STAFF RECOMMENDATION
1822 5th Avenue North
February 17, 2021

Application: New Construction—Addition
District: Salemtown Neighborhood Conservation Zoning Overlay
Council District: 19
Base Zoning: R6-A
Map and Parcel Number: 081081N00100CO, 081081N00200CO
Applicant: Jeff Zeitlin, Developer
Project Lead: Sean Alexander, sean.alexander@nashville.gov

Analysis and Findings: The applicant is proposing a revision to the addition, making it two feet (2') taller than it was originally approved.

Figure 2: Right Elevation approved in June 2020.

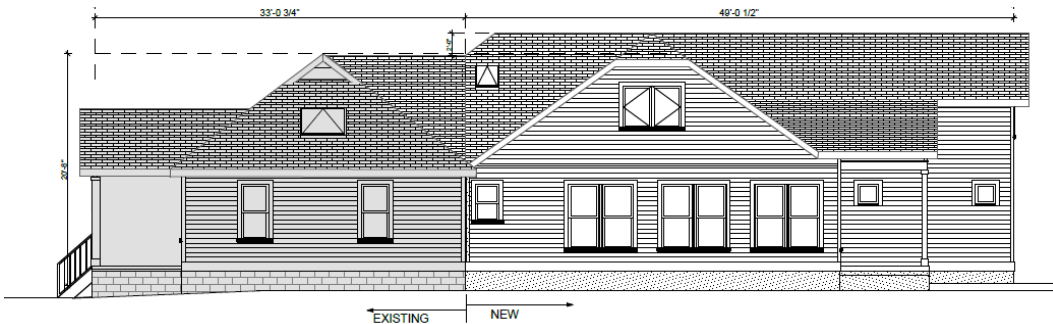
Height & Scale: The addition was approved with a cross-gabled roof with clipped ends, tying into the ridge of the original roof and matching its height. As construction got underway, the applicant determined that the ceiling height in the addition was too low for practical use, and as such they are proposing to increase the roof height of the addition by two feet (2').

The revised roof will still tie into the existing ridge as approved with a cross-gable extending to the rear of the historic building, with the revised roof then sloping up to a hipped form with a ridge two feet (2') higher than the original roof. The height will be achieved by increasing the roof pitch from 7.5/12 to 9/12. The difference in pitch is not so great as to be visually contrasting.

In general, additions should be kept within the silhouette of an historic house. However, in instances like this where the historic house is only one story, the Commission has approved proposals that either increase the ridge height of the historic house, or additions behind the house that rise as much as two feet (2') taller than the original roof. The former type of taller addition, known as a ridge-raise, is not possible on this house due to its uncommon Dutch Hip roof form.

The eaves toward the rear of the addition will also be two feet (2') taller. Staff finds that the additional height will not impact the character of the historic house because they are so far to the rear.

With the revised roof height, Staff finds that the height and scale of the addition will be appropriate and that it will meet sections III.A, III.B, and IV.B of the design guidelines.

Recommendation: Staff recommends approval of the proposed addition with the revised roof height, with the same conditions that were in the June 2020 approval:
